Addendum 1

To: Landscape Bidders	LANDSCAPE ADDENDUM	
	Addendum.#	1
	Date	April 14, 2026
	Project	Prince of Wales
	Project #	Project 2025-68
Description of Addendum

MODEL 70

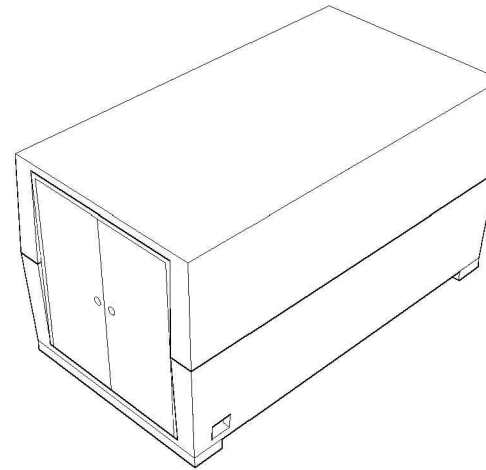
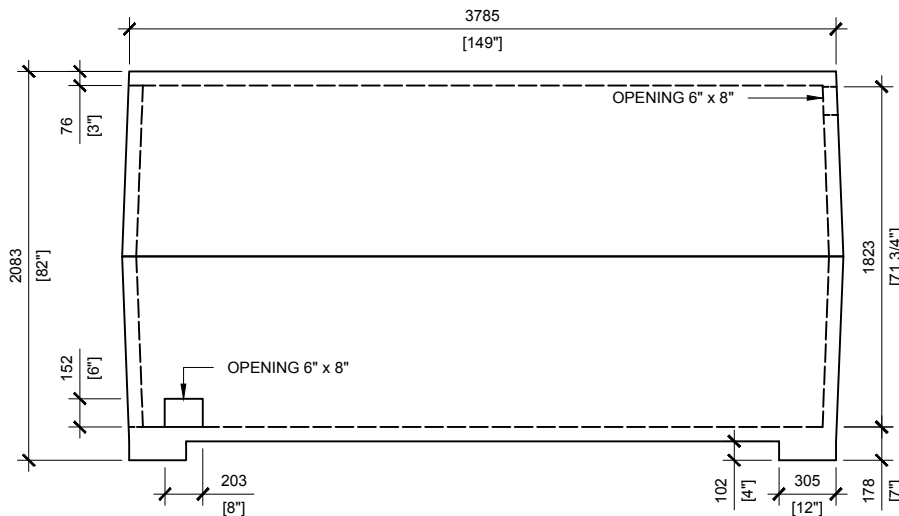
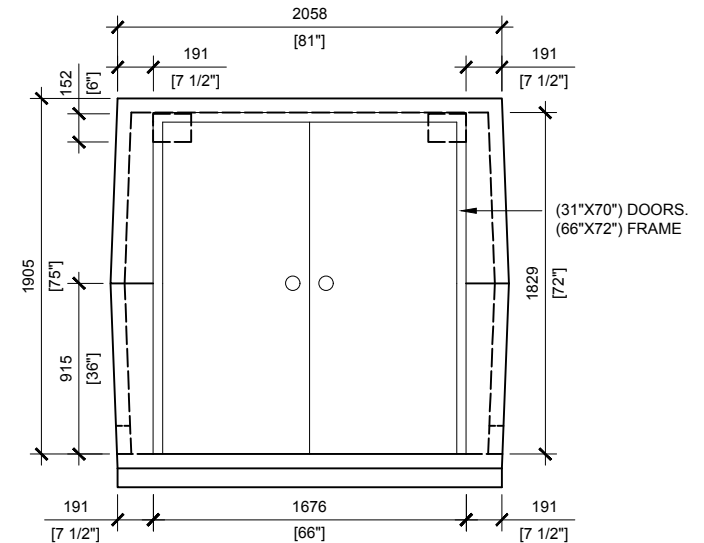
1. Can you please confirm the weight, make and model of the existing bunker being relocated on line item 14?

4. Are the specs and details regarding the concrete shed available we will have to know the supplier and size/model?

The bunker is from Brooklyn Concrete Products, Model 70, and weighs 16,000 lbs (7,257kg). Cut sheet attached.

Cut sheet on concrete bunker attached.
